TMS DWG. NO.
SCALE: 1" = 10'
REVISIONS
NO. DATE DESCRIPTION BY
5 8-6-03 PER ODOT D.G.G.
4 6-3-03 NOTE FOR POLE #4 D.G.G.
3 5-29-03 PER CITY DESIGN. D.G.G.
2 4-2-03 PER CITY/ODOT REVIEW. D.G.G.
1 6-28-02 PER CITY/ODOT REVIEW. D.G.G.
DATE: FEB. 2001
ASSOCIATED TRANSPORTATION ENGINEERING & PLANNING INC.
A.T.E.P., Inc. P.O. Box 3047 Salem, OR 97302
Tel.: 503-364-5066 FAX: 503-364-1260 e-mail: dwatep@citlink.net
SALEM, OREGON
THE HOME DEPOT
LANCASTER DR. & HWY. 22 S. RAMP
EQUIPMENT PLAN

SHEET 50 OF 54
JOB NUMBER 01-910

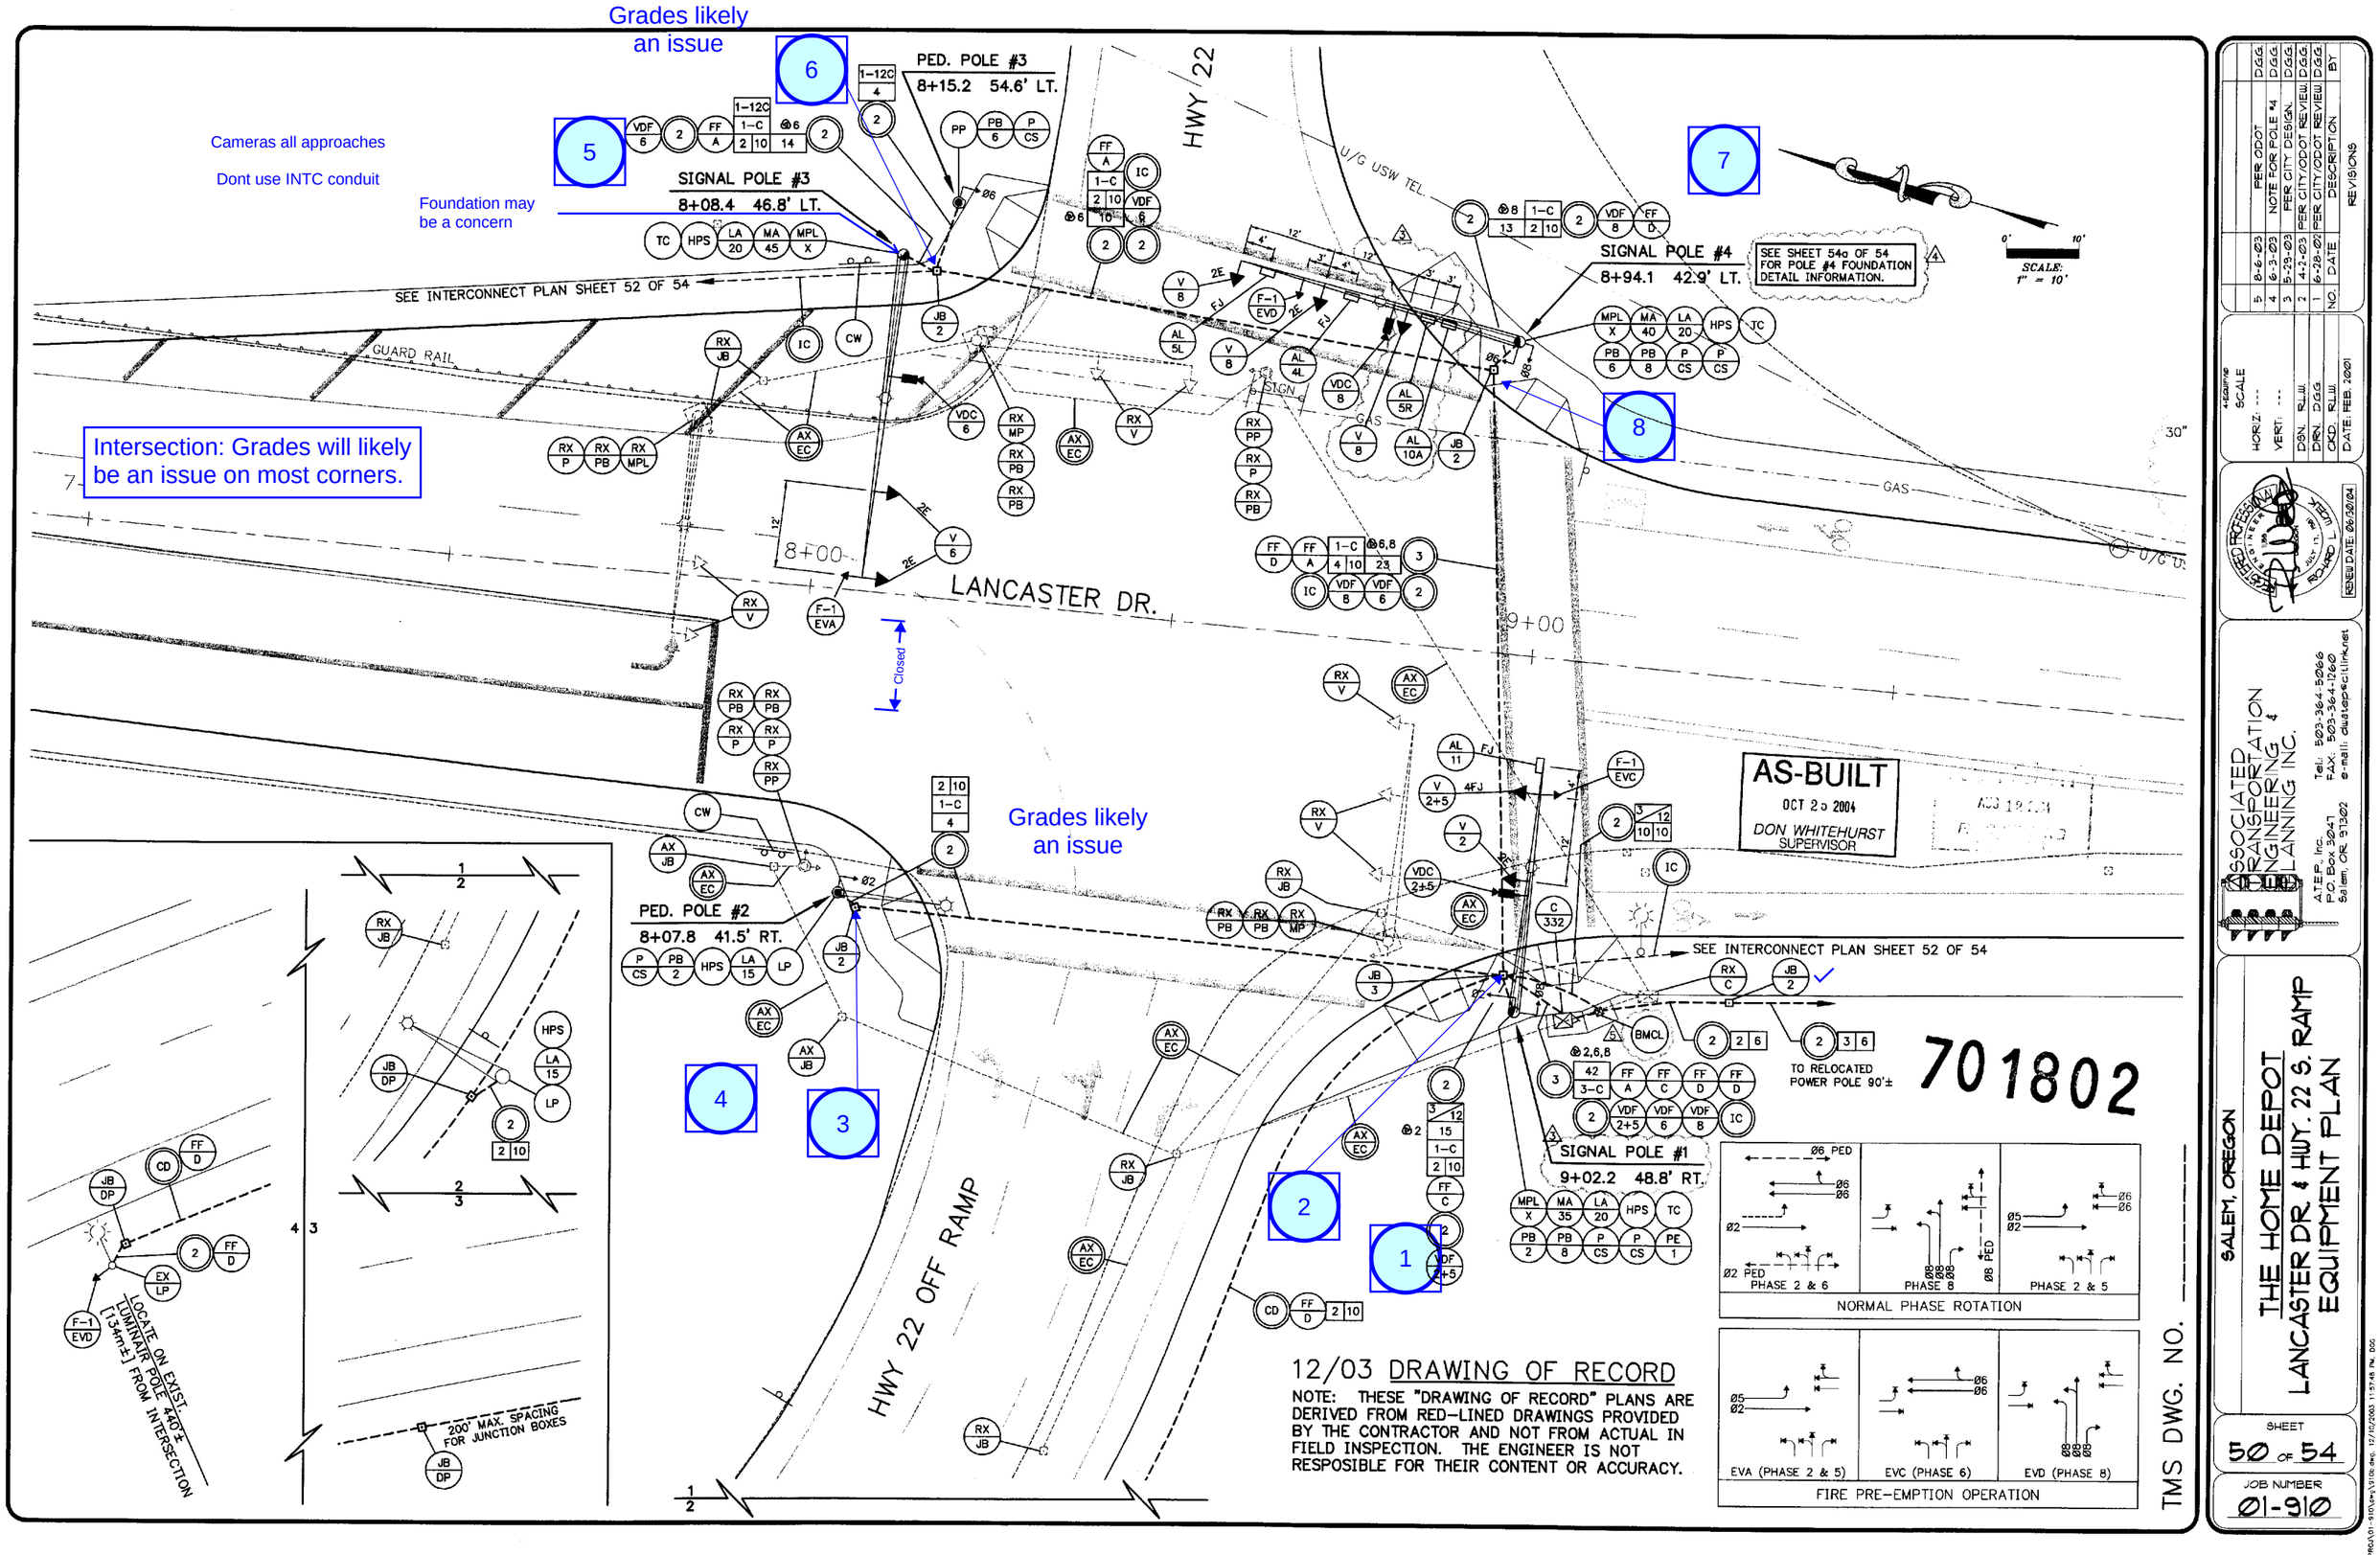
Grades likely an issue
Cameras all approaches
Dont use INTC conduit
Foundation may be a concern
Intersection: Grades will likely be an issue on most corners.
Grades likely an issue
PED. POLE #3
8+15.2 54.6' LT.
SIGNAL POLE #3
8+08.4 46.8' LT.
SIGNAL POLE #4
8+94.1 42.9' LT.
SEE SHEET 54a OF 54 FOR POLE #4 FOUNDATION DETAIL INFORMATION.
SEE INTERCONNECT PLAN SHEET 52 OF 54
GUARD RAIL
HWY 22
U/G USW TEL.
LANCASTER DR.
8+00
9+00
Closed
PED. POLE #2
8+07.8 41.5' RT.
SIGNAL POLE #1
9+02.2 48.8' RT.
TO RELOCATED POWER POLE 90'±
HWY 22 OFF RAMP
LOCATE ON EXIST. LUMINAIR POLE 440'± [134m±] FROM INTERSECTION
200' MAX. SPACING FOR JUNCTION BOXES
AS-BUILT
OCT 25 2004
DON WHITEHURST
SUPERVISOR
701802
NORMAL PHASE ROTATION
PHASE 2 & 6
PHASE 8
PHASE 2 & 5
FIRE PRE-EMPTION OPERATION
EVA (PHASE 2 & 5)
EVC (PHASE 6)
EVD (PHASE 8)
12/03 DRAWING OF RECORD
NOTE: THESE "DRAWING OF RECORD" PLANS ARE DERIVED FROM RED-LINED DRAWINGS PROVIDED BY THE CONTRACTOR AND NOT FROM ACTUAL IN FIELD INSPECTION. THE ENGINEER IS NOT RESPOSIBLE FOR THEIR CONTENT OR ACCURACY.
